**Record of Decision Amendment
for Soil and Dry Sediment
at the RVAAP-01 Ramsdell Quarry Landfill**

**Ravenna Army Ammunition Plant
Ravenna, Ohio**

COMMENT RESPONSE

Subject: Read-Ahead for Requested Clarification Meeting Regarding Ohio EPA Notice of Deficiency – Comments for the Draft Record of Decision (ROD) Amendment for Soil and Dry Sediment at the RVAAP-01 Ramsdell Quarry Landfill at the Ravenna Army Ammunition Plant, Ravenna, Ohio, Dated March 13, 2013(Work Activity No. 267-000859-163)

Figure 3. RQL Site Features and Fencing Extent Under Alternative 8

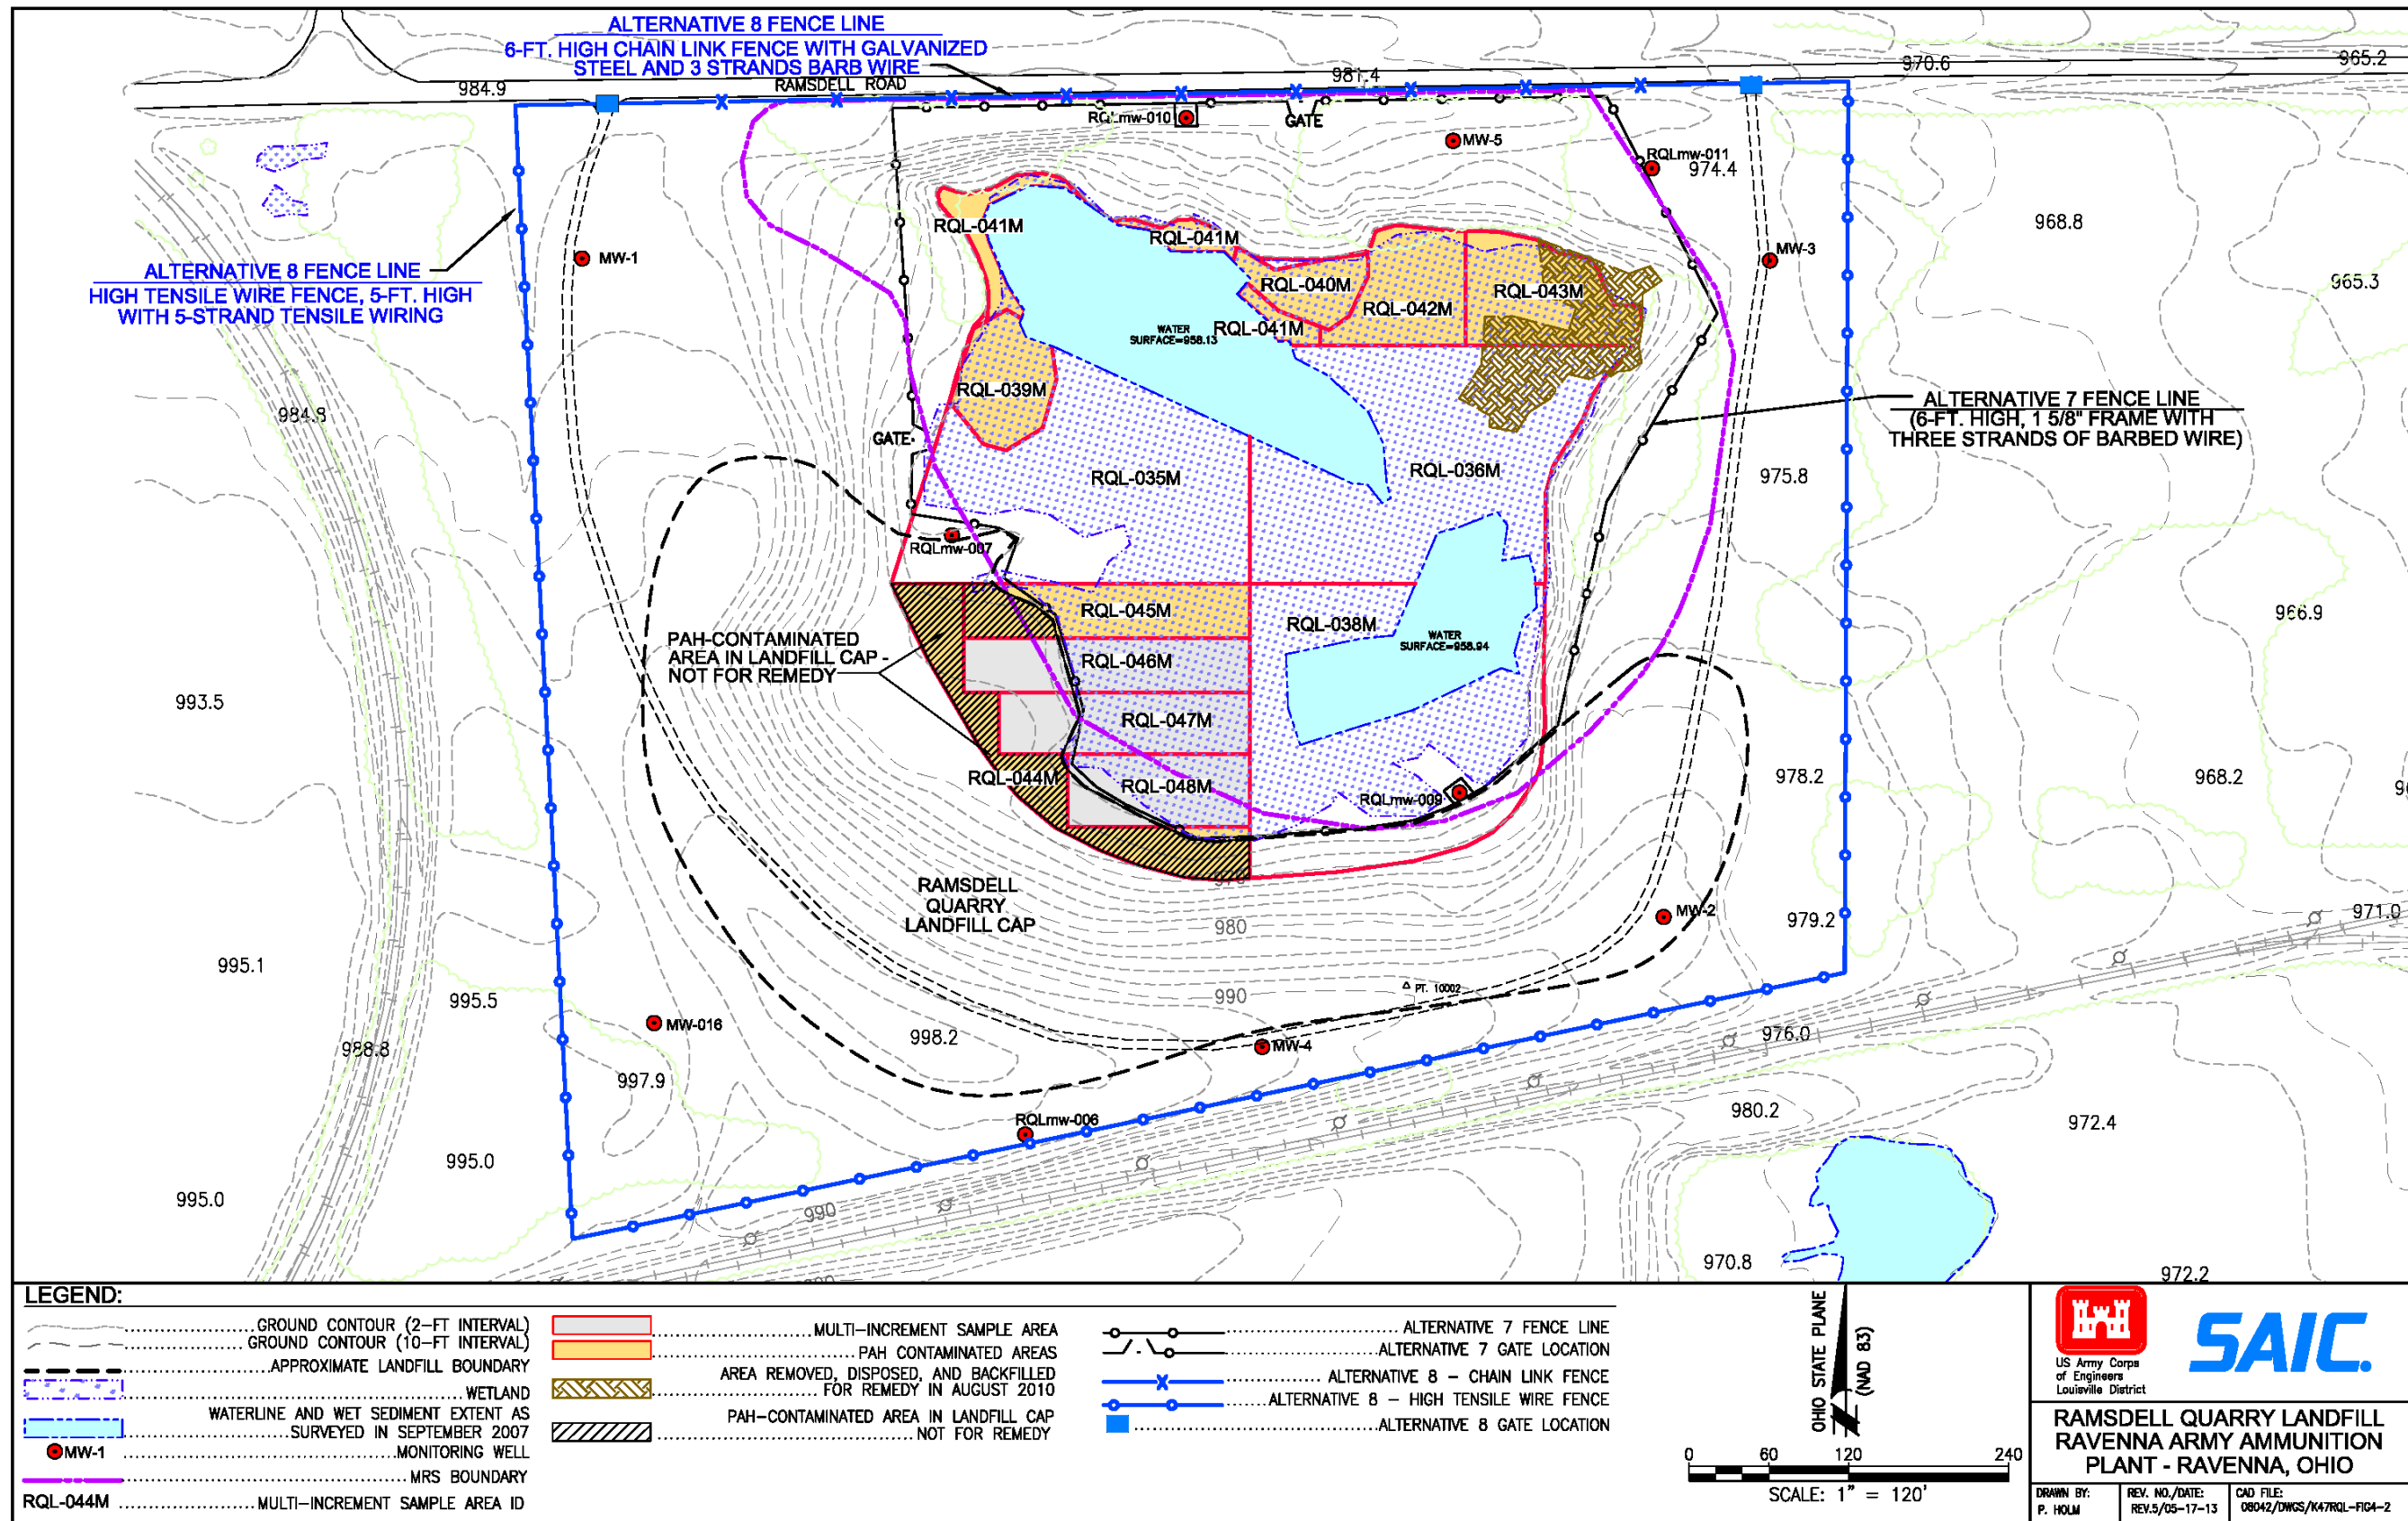
Ohio EPA Comment 1: Page 11, Line 11 and Figure 3 – The text states that the gate will be 6 feet high, but it does not state the height of the fence. Please include the height of the fence in the text and on Figure 3.

Army Response: Agree. The text on Page 11, Line 11 has been revised as presented below. In addition, Figure 3 has been revised to indicate the chain link fence will be 6-feet high (as italicized).
